## TECHNICAL MEMORANDUM

SUBJECT: Technical Memorandum 3 – Part 1 & 2: *Basin Management Alternatives for the Puente Basin Groundwater Management Plan*

Attachment A: Response to Comments and Updates to Draft TM-3 Part 1

## **ATTACHMENT A – RESPONSES TO COMMENTS AND OTHER UPDATES MADE TO THE OCTOBER 2024 DRAFT TECHNICAL MAMORADUM 3 – PART 1: BASIN MANAGEMENT ALTERNATIVES FOR THE PUENET BASIN GROUNDWATER MANAGEMENT PLAN (TM-3 – PART 1)**

**Basin Management Alternative 2**  
*Potential Location for Wells and Facilities*

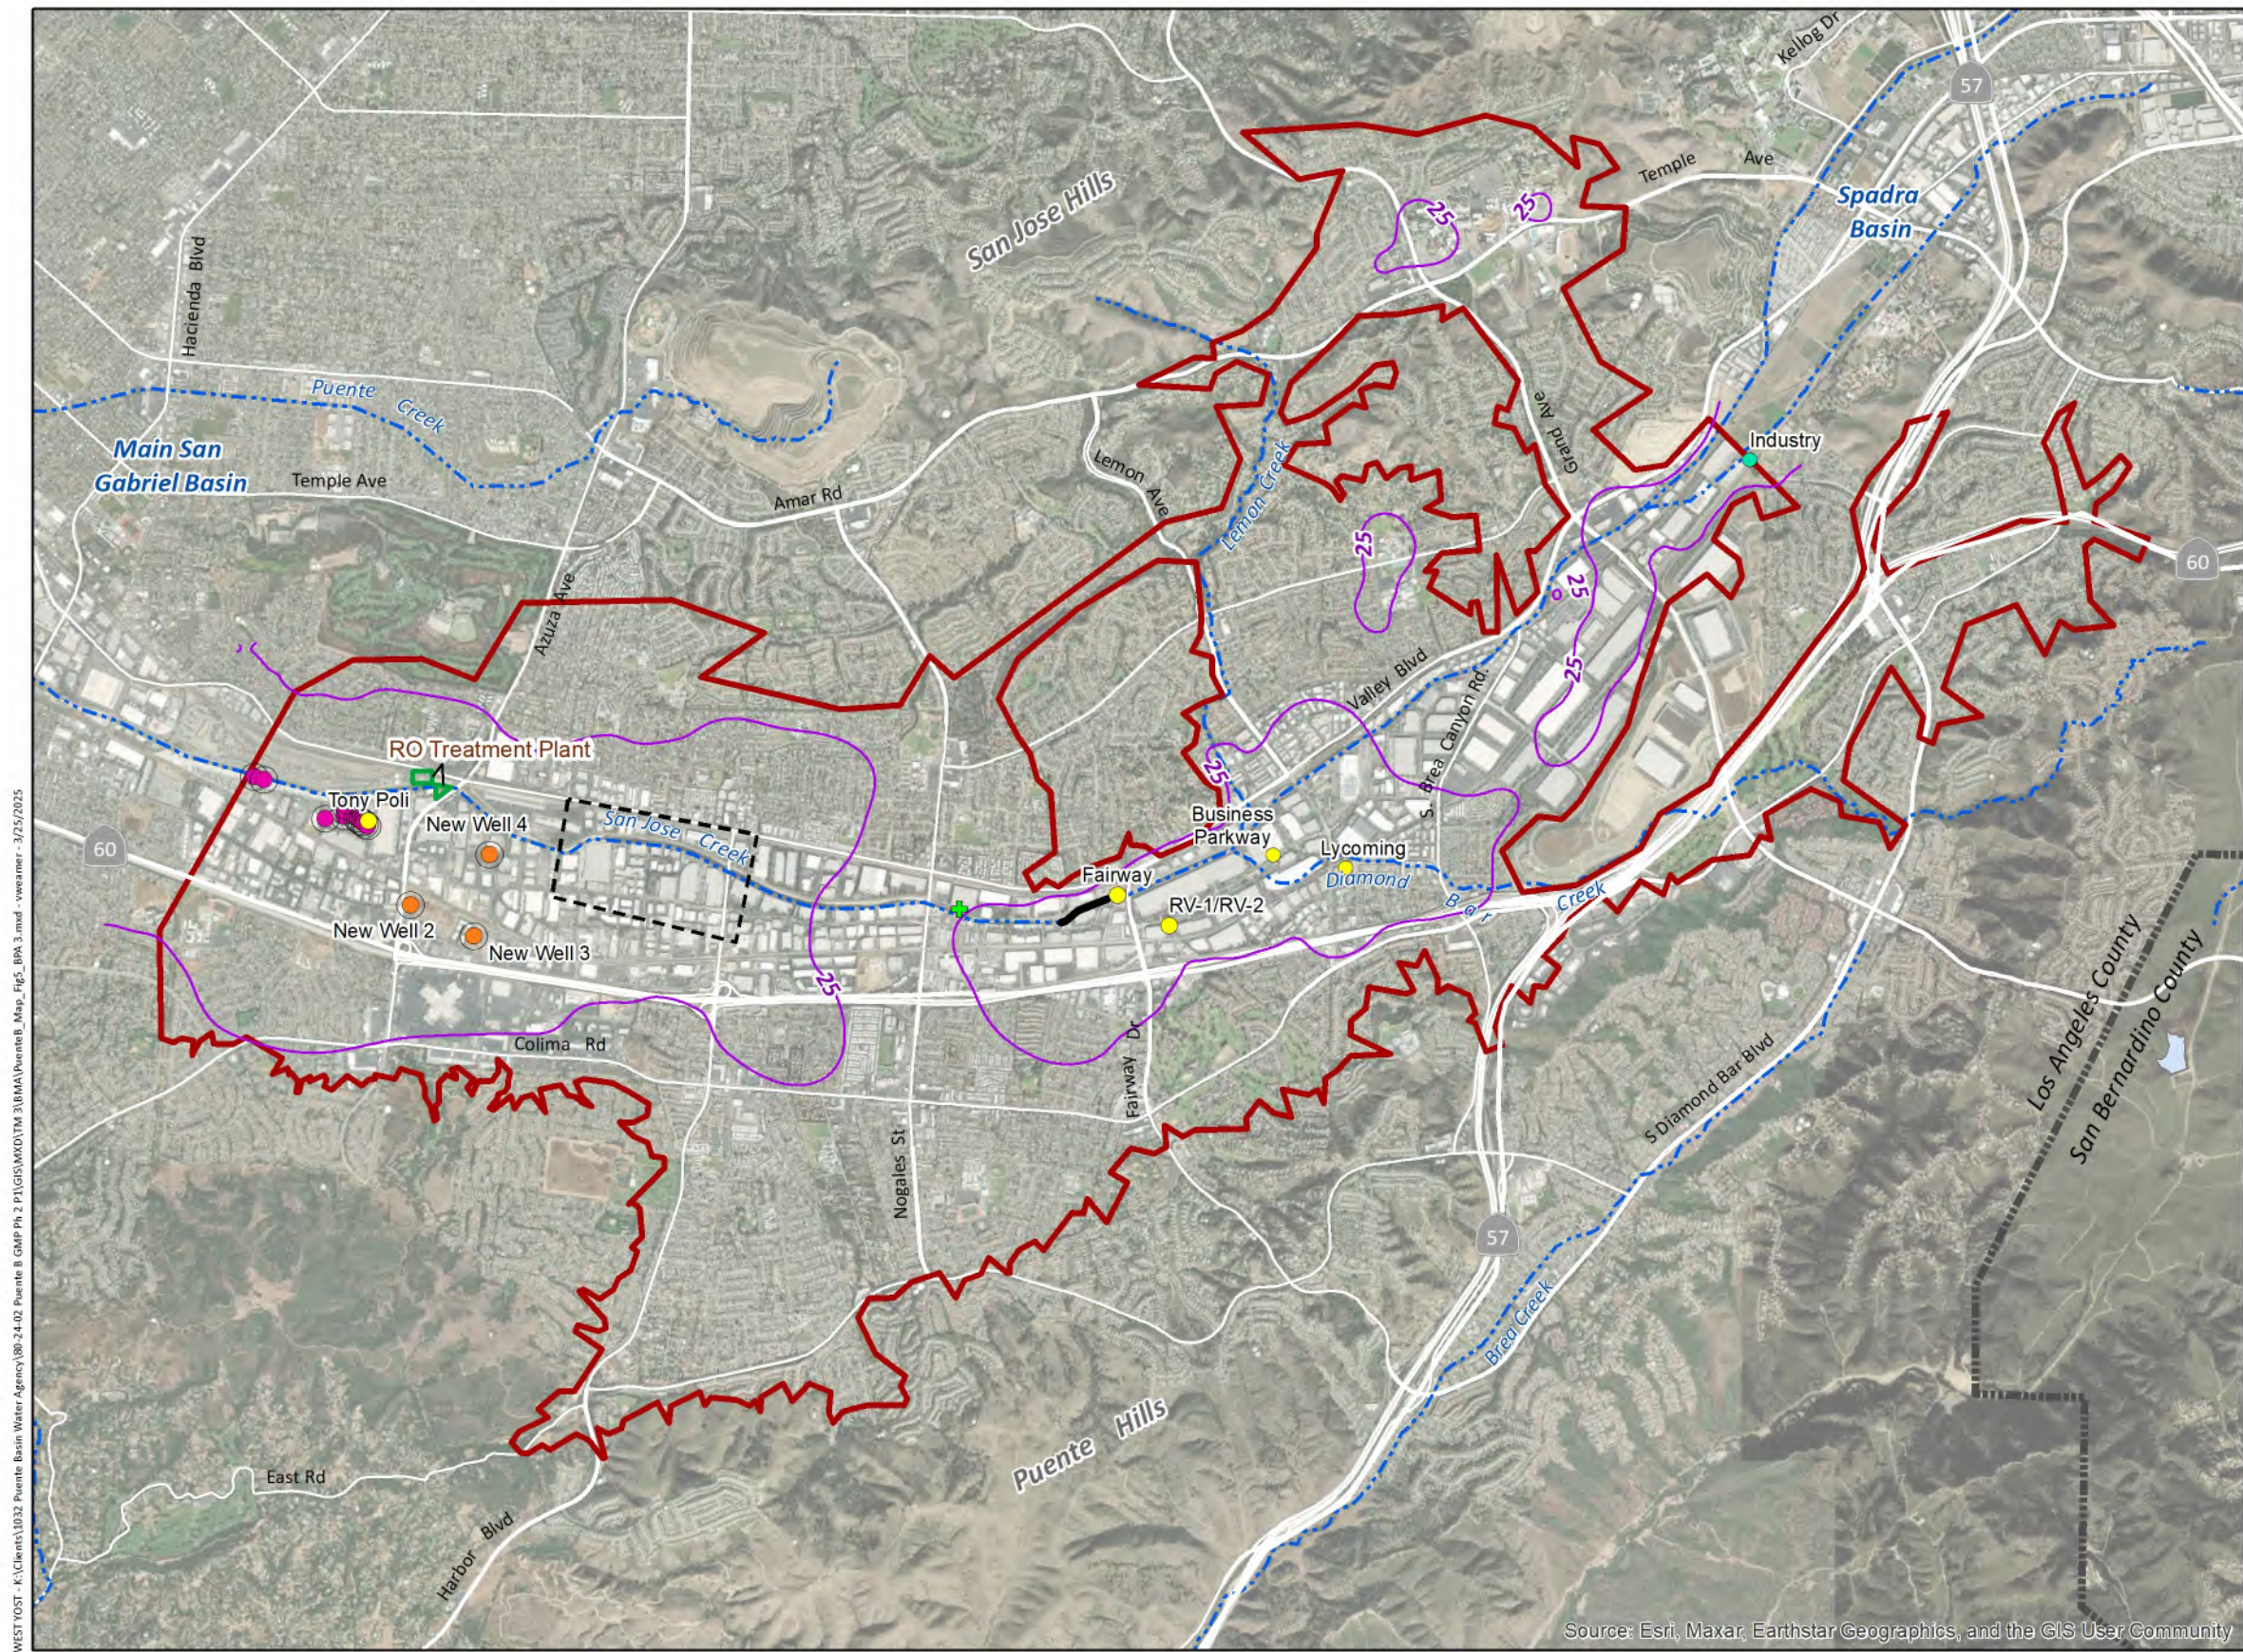
**Comment 3:** Basin Management Alternative 6:

Under the New Potable Water Supply bullet, it is not clear whether the RO recovery rate was considered in determining the amount of water available from the Pomona WRP. Please clarify.

**Response:** In Section 3 of TM-3, the bullet points for “New Potable Water Supply” in Alternatives 2 through 6 were revised to reflect supply volumes based on an 80% recovery rate. Additionally, it is specified that an 80% recovery rate is assumed.
